3 September 2021

National Trust submission relating to Fort Street Public School Mod 1 - Design and layout changes

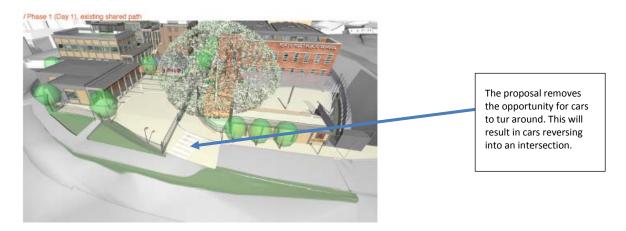
It has already been noted that the initial approved SSDA scheme was an over-development of the site, and already had a negative heritage impact towards the National Trust Centre. The revised scheme presents a three storey blank wall to the National Trust Centre.
